Approved Rear Elevation

As Proposed Rear Elevation

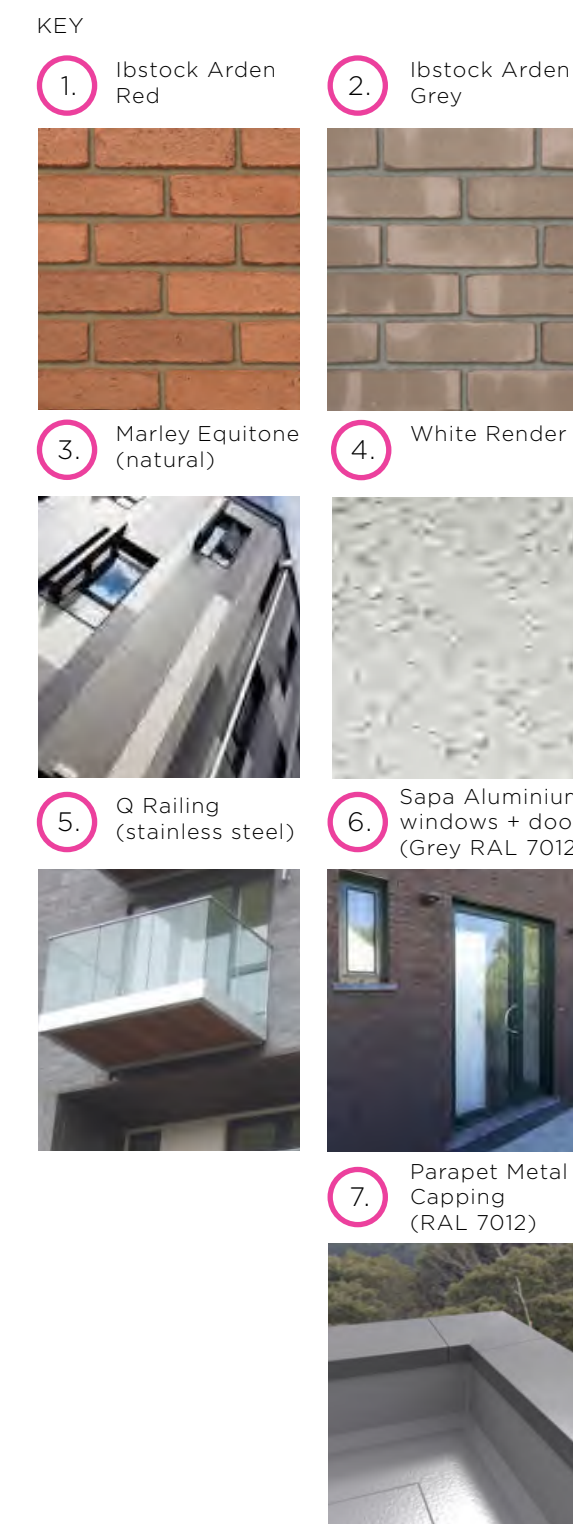
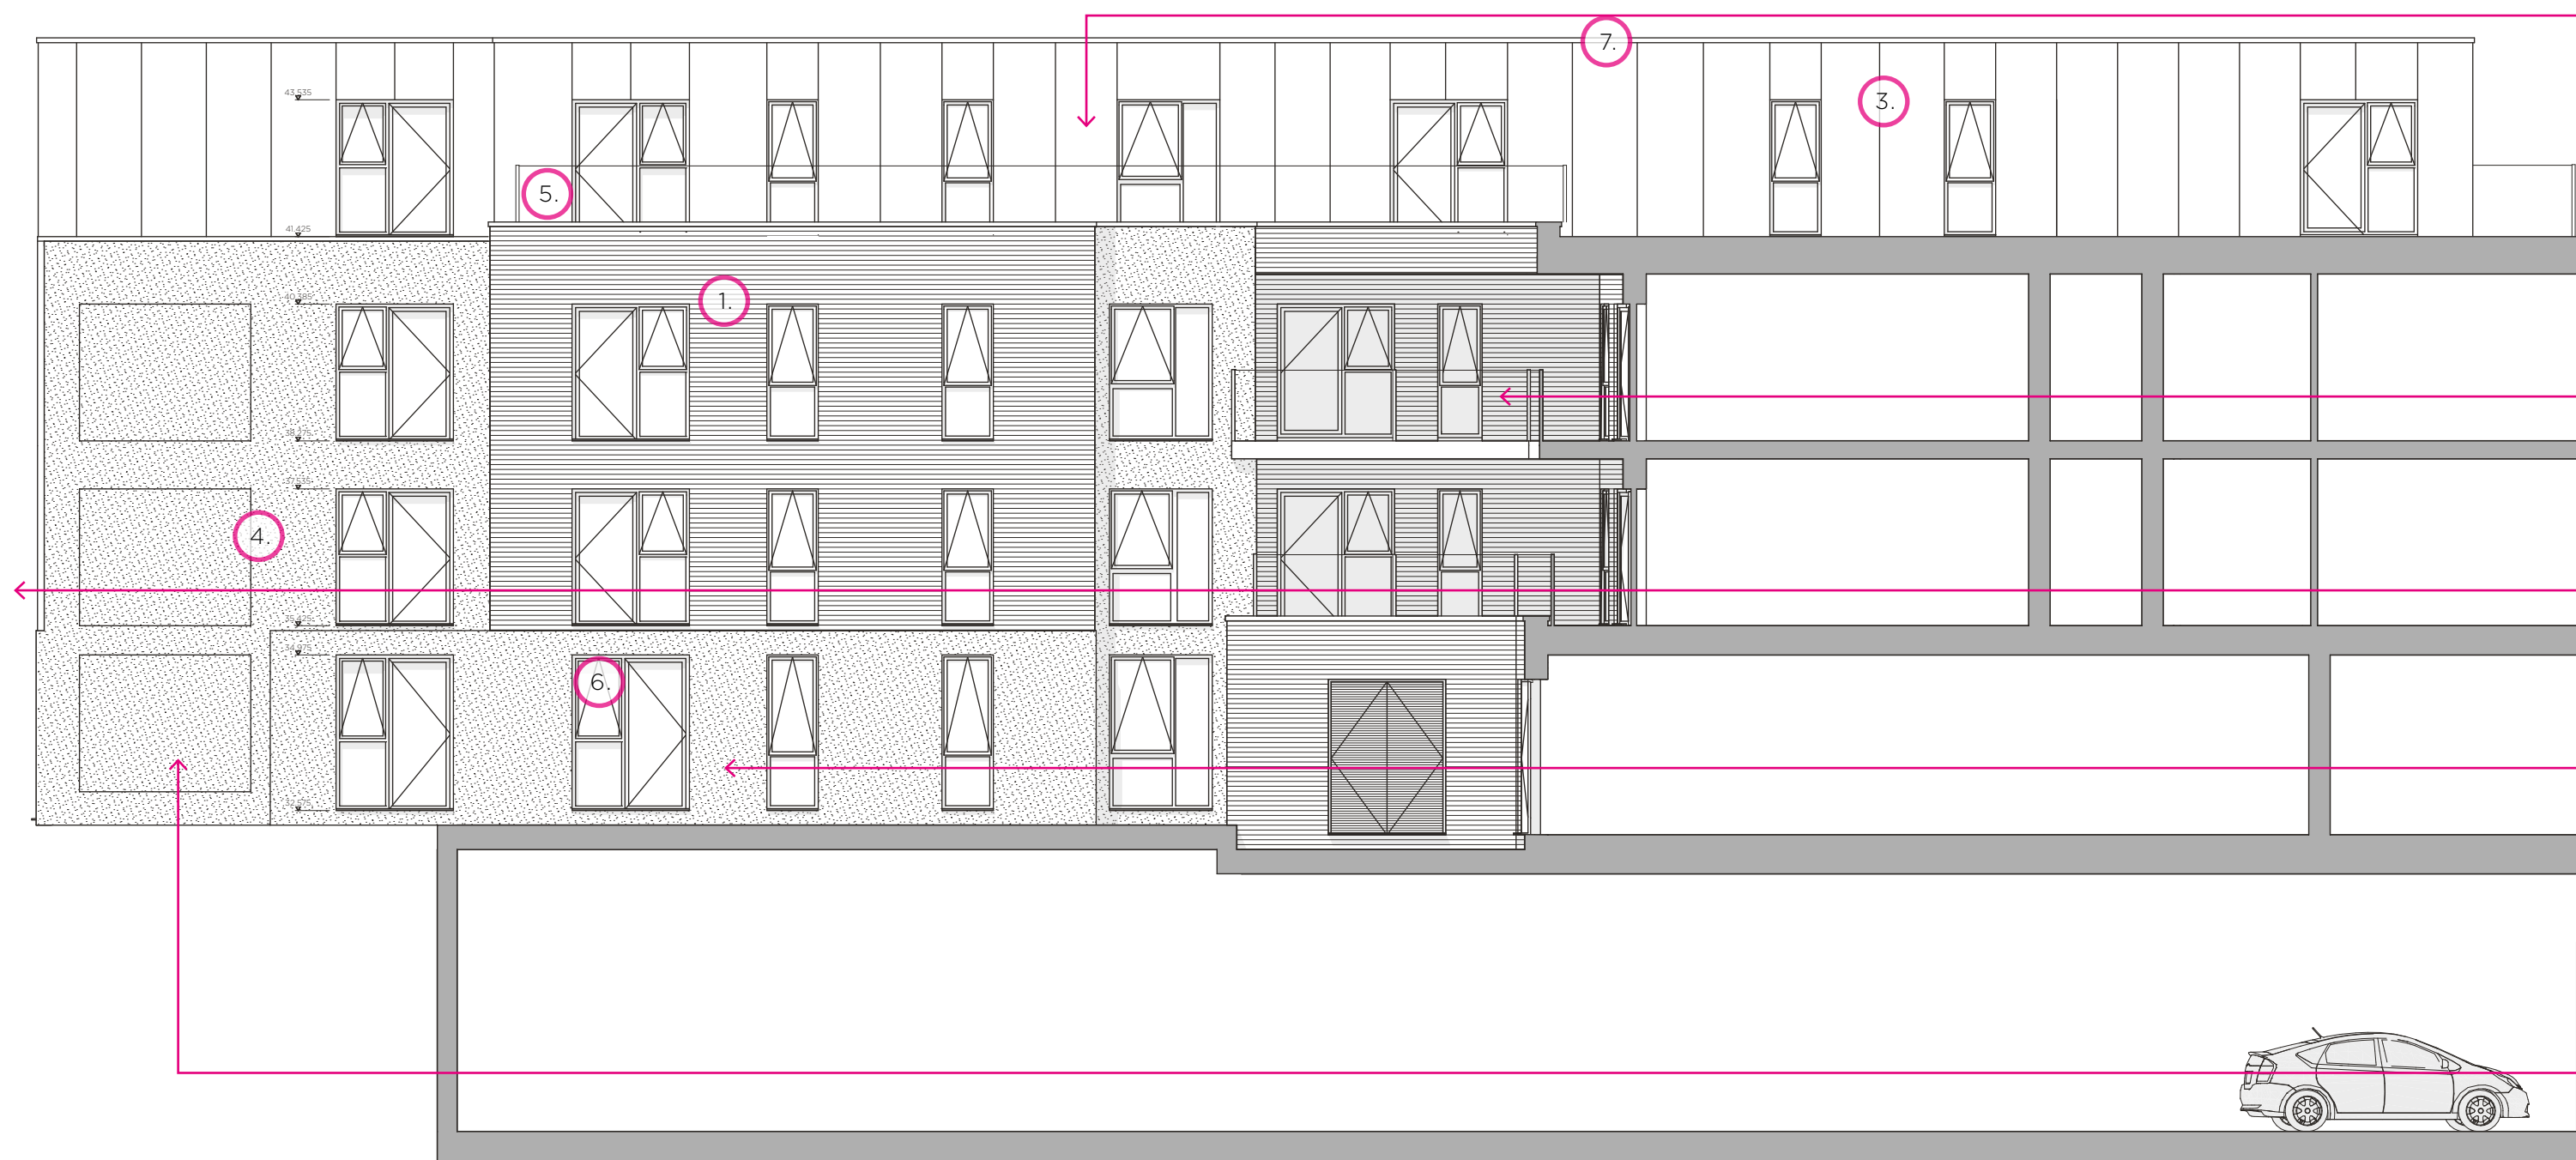
Fenestration layout changed to suit new internal layouts.

Proposed inset balcony to replace Juliet balcony and window layout.

Proposed building moved away from adjacent building.

Windows set to match the floors above.

Removal of windows and replacement of dummy windows due to new lift placement.
